Access Compliance Report Public Rights-of-Way (Curb Ramps)

Intersection ID: 28375 Main Street: CORNWALLIS_HALL_DR Cross Street: WHEATFIELD_RD Location: NE **Overall Compliance: No Severity Score: ADA ID: 3ED1FA8F9235** Ramp Type: Perp Initial Pass/Fail: Fail 25

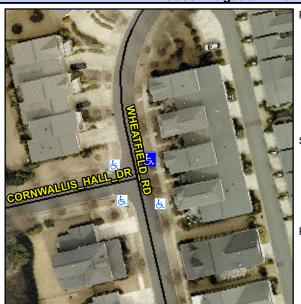
Field Measurements/Component Compliance								
Comp	liance Description	Data	Comp	liance Description	Data			
N/A	Ramp Length (in)	72.0	No	Ramp Slope (%)	12.3			
Yes	Ramp Width (in)	50.0	Yes	Ramp XSlope (%)	0.8			
N/A	Flare Type LT	N/A	N/A	Flare Type RT	N/A			
N/A	Flare Slope LT (%)	N/A	N/A	Flare Slope RT (%)	N/A			
N/A	Flare Traversable LT?	N/A	N/A	Flare Traversable RT?	N/A			
N/A	Landing Length (in)	N/A	N/A	DWS Provided?	N/A			
N/A	Landing Width (in)	N/A	N/A	DWS Contrast?	N/A			
N/A	Landing Slope (%)	N/A	N/A	DWS Length (in)	N/A			
N/A	Landing X Slope (%)	N/A	N/A	DWS Full Width?	N/A			
N/A	Landing Curb? (Y/N)	N/A	N/A	DWS Offset (in)	N/A			
N/A	Shared Landing?	N/A						
N/A	Gutter Ponding?	N/A	N/A	Gutter Slope (%)	N/A			
N/A	Gutter Lip Ht (in)	N/A	N/A	Gutter X Slope (%)	N/A			
N/A	Painted X Walk1?	No	N/A	Painted X Walk2?	N/A			
	X Walk 1 Direction	To W		X Walk 2 Direction	N/A			
N/A	X Walk 1 Width (in)	N/A	N/A	X Walk 2 Width (in)	N/A

Possible Solutions:	Col
Remove & Replace Entire Ramp.	N/A
•	Yes
	N/A
	N/A
	N/A
	N/A
Surveyor Notes:	N/A
N/A	N/A
	N/A
	N/A
	N/A
PROW/ADA:	N/A
Not Found, R304.2.2	N/A
,	N/A
	N/A
	N/A
